Deshbandhu Textile Mills Ltd

MSSFB # 1&2, Uttara Export Processing Zone, Shongalshi, Saidpur, Nilphamari.

23 June 2022

Dampness at several locations

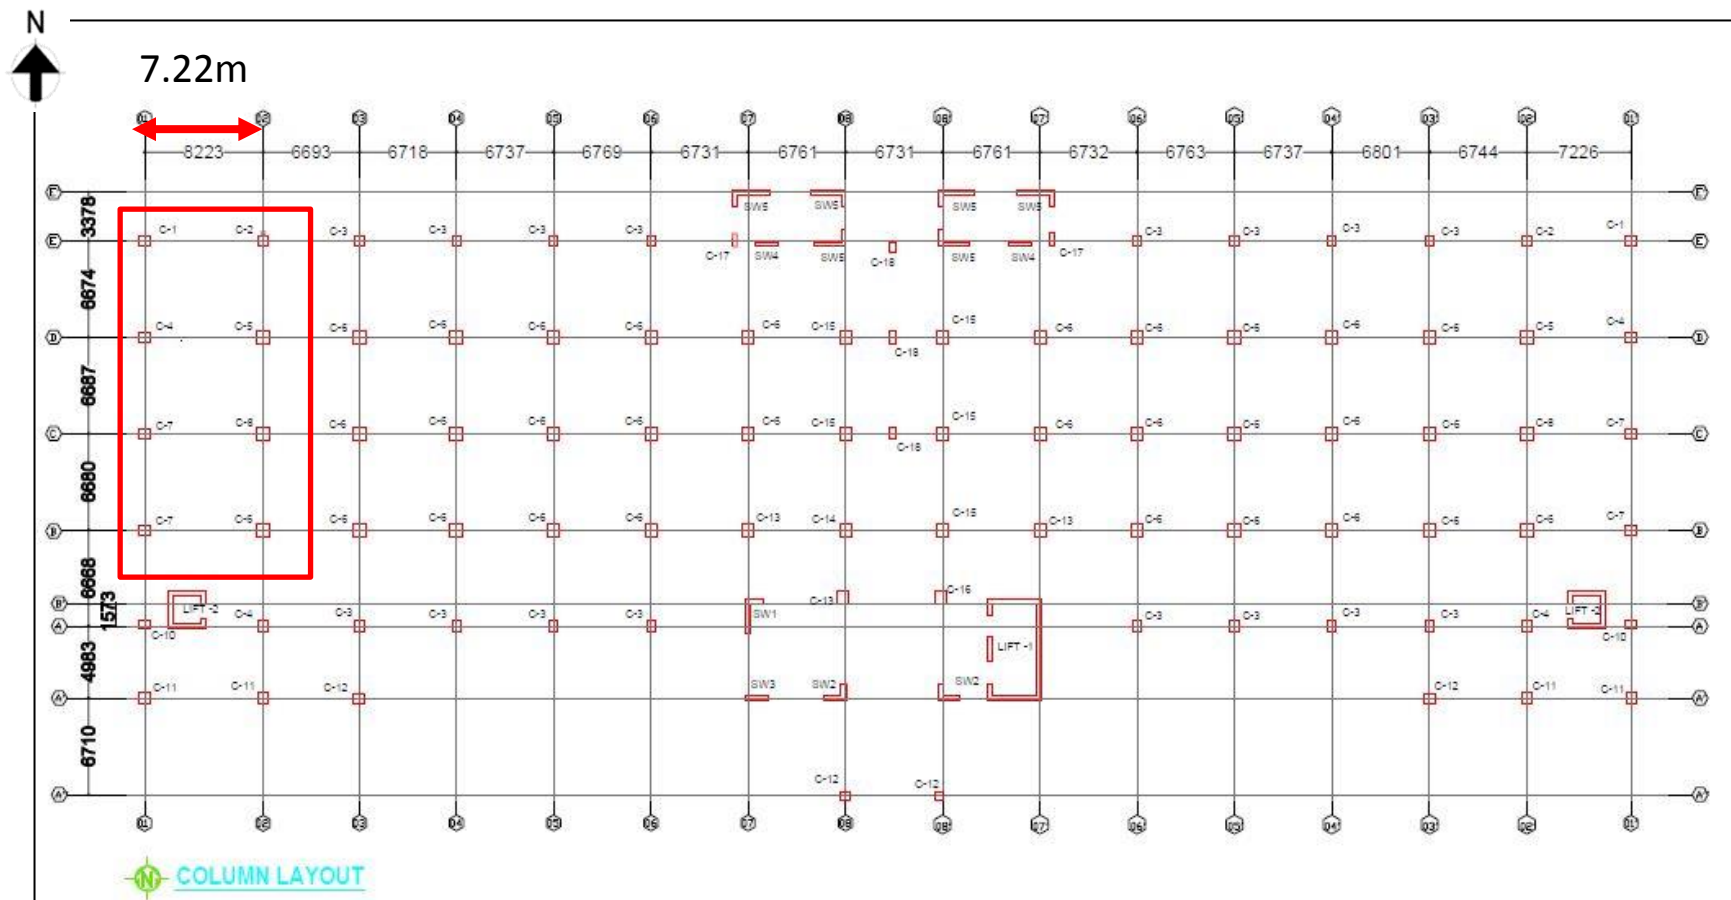
Severe dampness was found several locations of the structure (e.g façade, brick wall, column & beam). Factory engineer is required to investigate the source of dampness and take necessary measures to prevent the dampness.

Apparently lack of lateral stability

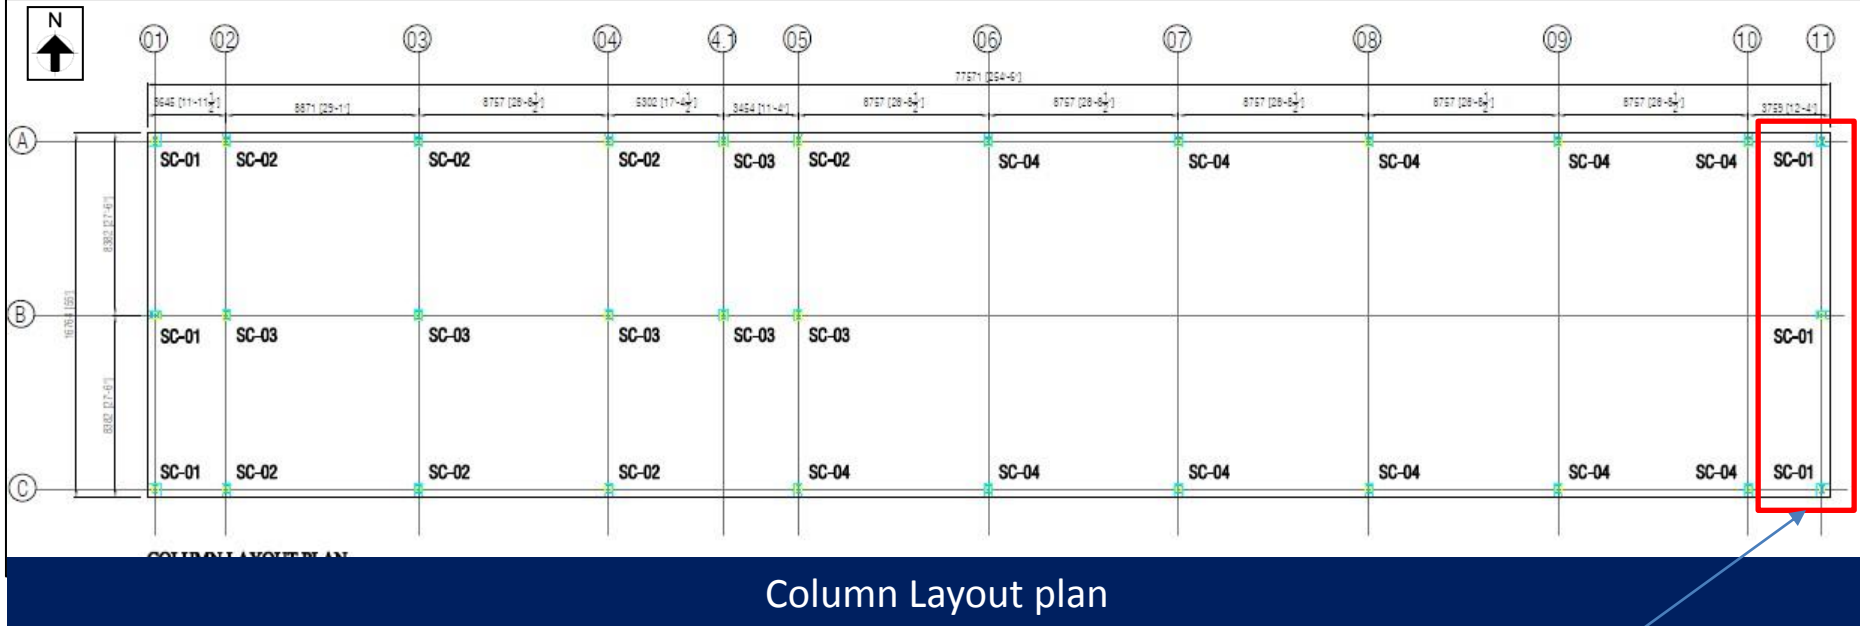
No bracing system/load transfer media provided

Poor connection at truss to column

No load transfer media provided from frame to frame along long direction. Besides, no roof bracing system is provided therefore there is no obvious lateral stability for this shed. In addition, poor connection was found at truss to column connection. Factory engineer is required to check the stability of the shed against the lateral forces. Also, check the connection adequacy for all connections against uplift forces.
